PEERMAN
P.O.A.D.P.

JOB NO. 5020.02 DATE: 5/31/2001

MDP/POADP # 720

Re: Peerman/De La Vega, Level 3 TIA

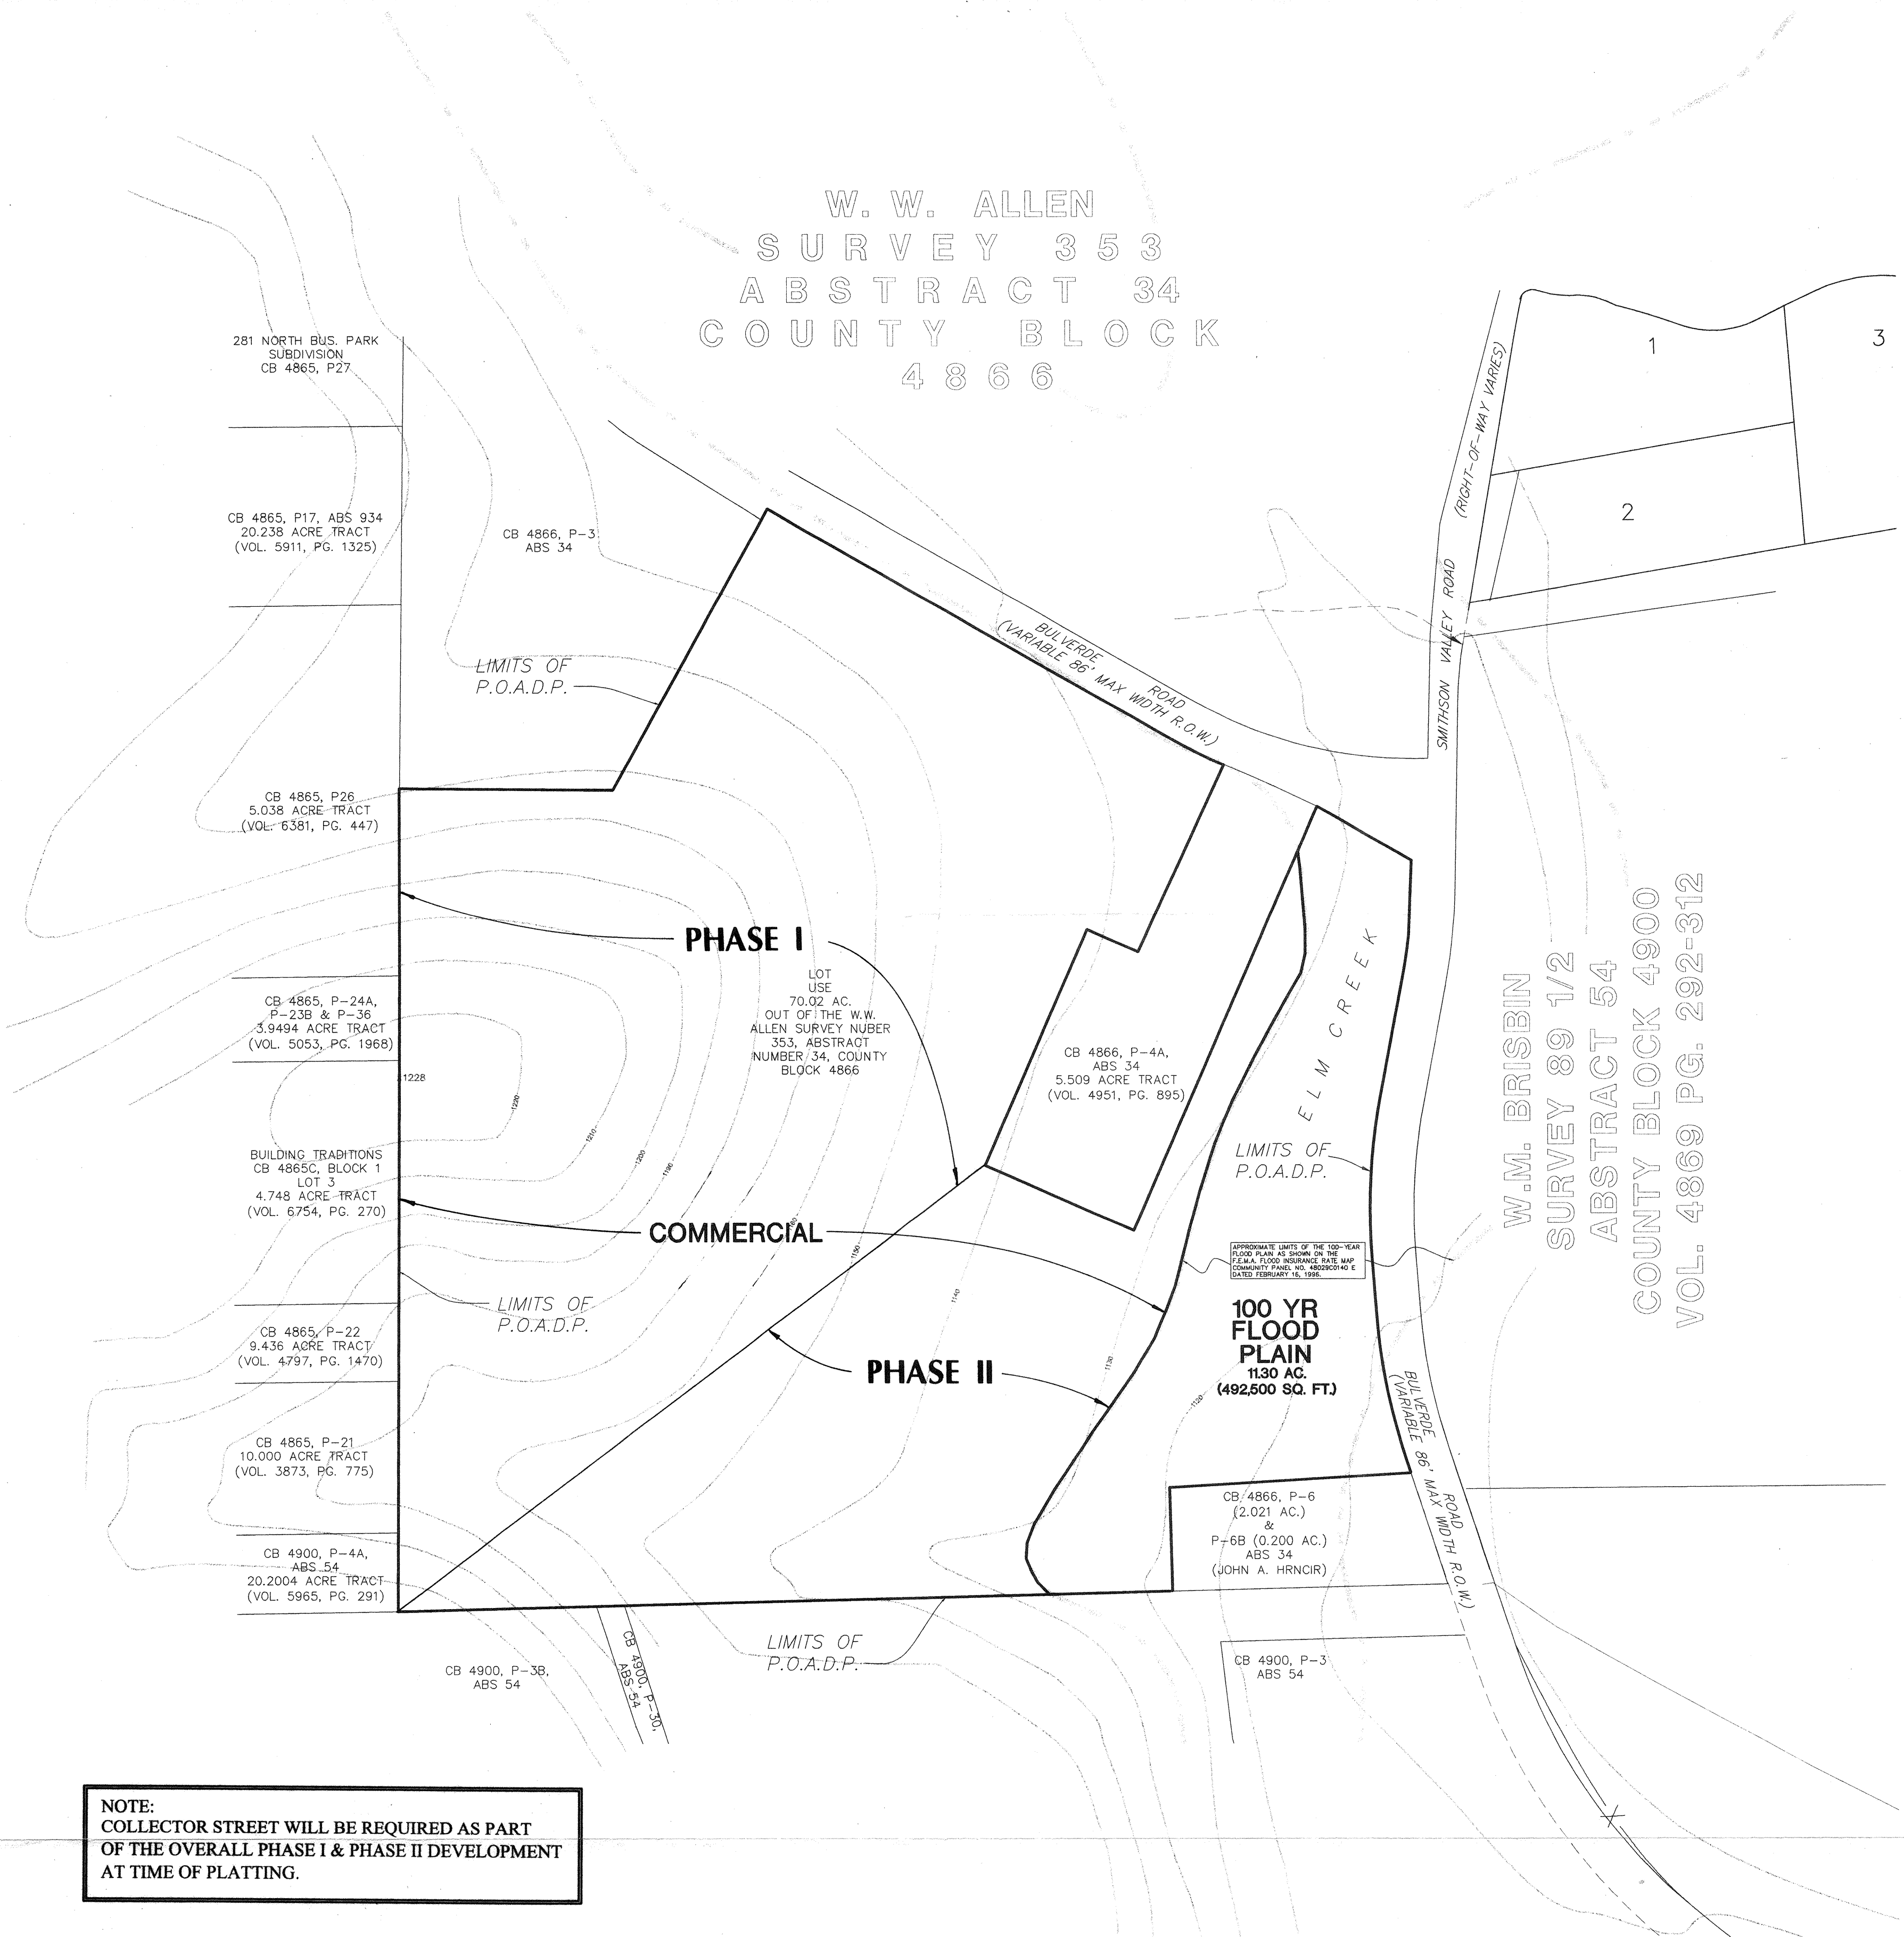
- In consideration of public safety and convenience, excessive grades by reason of topography should be avoided in street layouts and arrangements.
- Any access and R.O.W. issues along state facilities will need to be resolved with the Texas Department of Transportation (TXDOT). For information about these requirements you can contact TXDOT at 615-5814.

- a.) The proposed developments Peerman and De La Vega are located near each other and will require off-site improvements in conjunction with the on-site construction. Widening of Bulverde Road to a Primary Arterial type B (86 feet ROW) adjacent to the proposed project limits.

- b.) The Developer shall provide 43 feet of ROW from the centerline of Bulverde Road adjacent to these projects. This will require a property dedication by the developer.

- c.) Installation of a traffic signals at the intersection of Bulverde Road and Smithson Valley.
 - d.) Construction of a signalized intersection at the proposed Peerman Driveway 2 on Bulverde Road a min. ¼ mile away from the Bulverde Road / Smithson Valley intersection and a min. of ¼ mile away from the De La Vega subdivision road traffic signal.

- e.) Construct a signalized intersection at the intersection of De La Vega subdivision road and Bulverde Road a min. of ¼ mile away from the Peerman Driveway 2 and a min. ¼ mile away from the Bulverde interchange at US Highway 281.
- This development will need to comply with tree preservation ordinance #85262. For information about these requirements you can contact Building Inspections at 207-7102.
 - It will be expected that you will plat all of the property depicted in your Master Development Plan (M.D.P.) (formerly POADP), to include floodplains, drainage areas and open space.
 - I would encourage you to work closely with the school district, so that they can plan accordingly.

Comments: BULVERDE ROAD IS ON THE MTP REQUIRING A MIN. OF 80' ROW. PROPOSE MDP ADDRESS THOROUGHFARE PLAN.

*- Has a flood study been completed to
establish BFE's?*

- Drainage plan?
